Service Bulletin

Alternate Airbox Upgrade.

Document: Service Bulletin SB-GA8-2008-41,
Issue 1

Figure 1

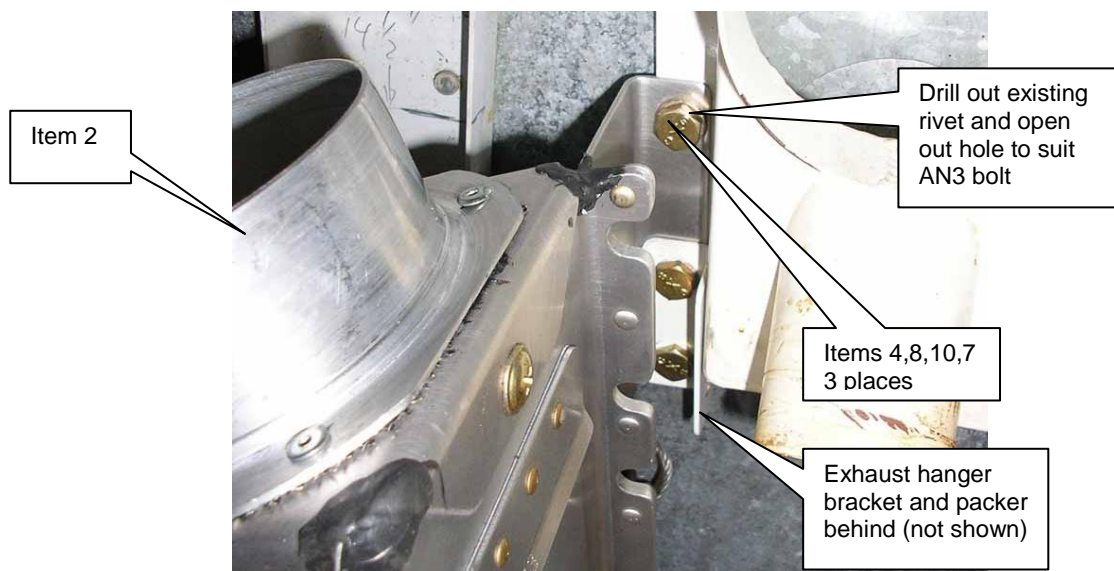
1. Remove existing air intake plenum assembly.
2. Remove the injector adapter clamps.
3. Clean sealant from injector body.
4. Remove alternate air cable from the control console.
5. Remove upper mounting of muffler cable hanging assembly from the exhaust hanger bracket.
6. Remove the exhaust hanger bracket and packer attached to the cabin heat valve assembly, and retain.
7. Drill out the 5/32" (3.97mm) rivet, directly above where the exhaust hanger bracket was (see Figure 1) and open out to suit AN3 bolt.
8. Place the new alternate airbox assembly over cabin heat valve assembly flange. Centrally align the 3 slotted holes. Refer to Figure 1.

Figure 2

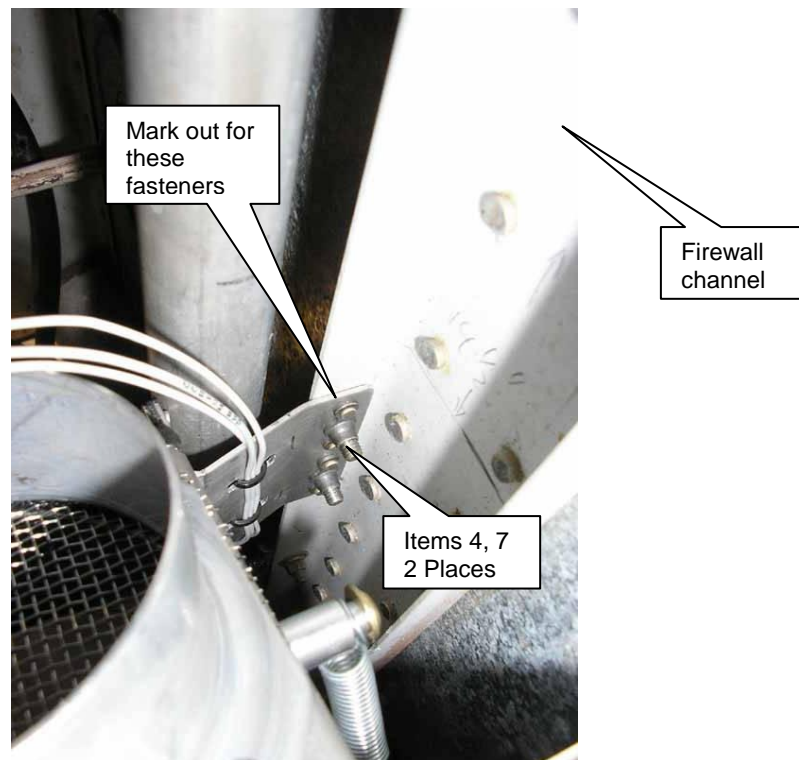
- While in place, mark out 2 holes in the side of the firewall channel and drill to suit AN3 bolt. Refer to Figure 2.

Figure 3

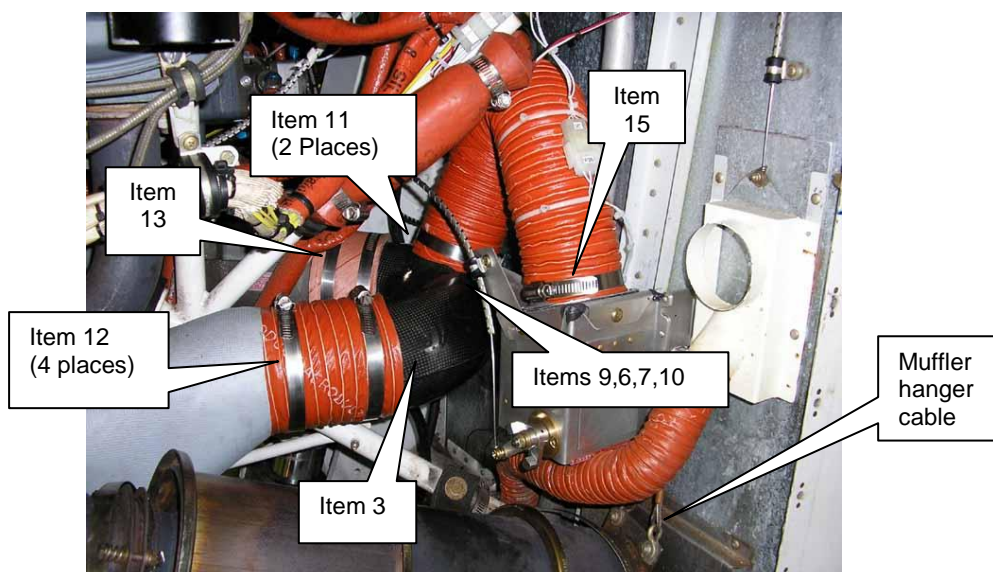
- Remove the air intake plenum drain hose (3 sections and Tee piece), and replace with item 14 (one length of MIL-H-6000 ¼ hose 18.5 inches long).
- Attach the new alternate airbox assembly with retained exhaust hanger bracket, and spacer, using AN hardware supplied in kit (see Figure 1). Fit three AN970-3 washers and three MS21042-3 10-32 reduced hex nuts on the inside of the firewall.
- Fit the new airbox trunk to the injector with hose, P/N LW-15569 (the cut out in hose LW-15569 goes over the injector inlet). Fit the other end of trunk to the air filter assembly with scat 16 hose. Refer to Figure 3.

Figure 4

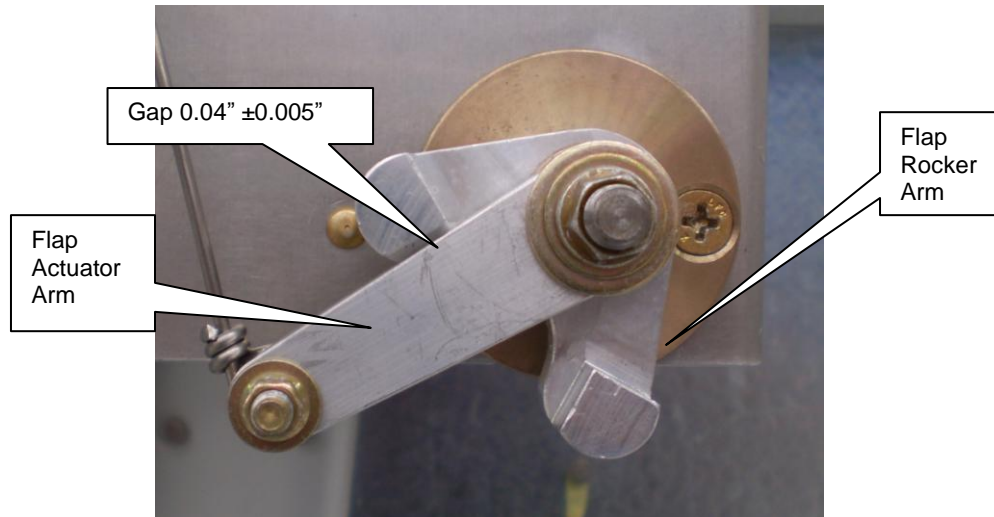
13. Install clamps and tighten.
14. Install scot 12 hose (18 inches long) from the alternate airbox to the airbox trunk and fit clamps and tighten.
15. Re-attach the muffler hanger cable assembly.
16. Install alternate air cable, (item1). Push the alternate air knob in fully. Rotate the Flap Rocker Arm fully anti-clockwise when viewed looking at the airbox in the aft direction. The Flap Actuator Arm is to be set 0.040" +/- 0.005" from the upper stop of the Flap Rocker Arm as shown in Figure 4. Adjustments can be made by loosening the Cable Clamp and sliding the cable out through the Clamp. Secure the cable with the Cable Clamp following any adjustment. Cycle the alternate air control from closed to open several times to ensure correct operation.
